Interactive comment on “A national topographic dataset for hydrological modeling over contiguous United States” by Jun Zhang et al.

Replies to Reviewer1:

Replies to Reviewer2:

Fig. 1. Figure 9: (a) the elevation along an example stream segment (shown in c) before and after smoothing applied along the stream divided into segments by dashed lines; (b) the ponding depth along the ma

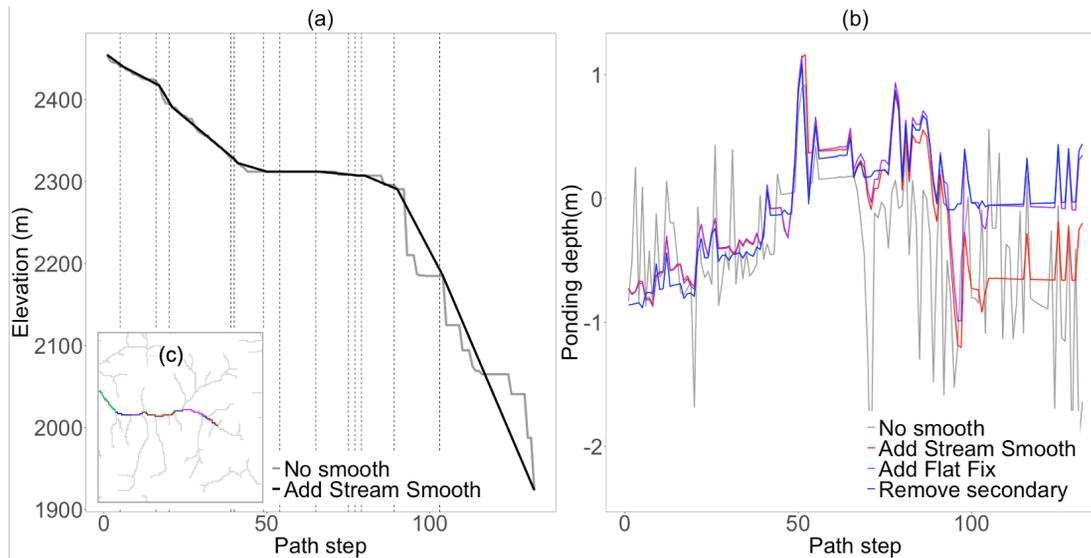
23. Figure 9: These colors are difficult to differentiate in both panels a and b.

Reply: The colors in Figure 9 have been updated as attached.
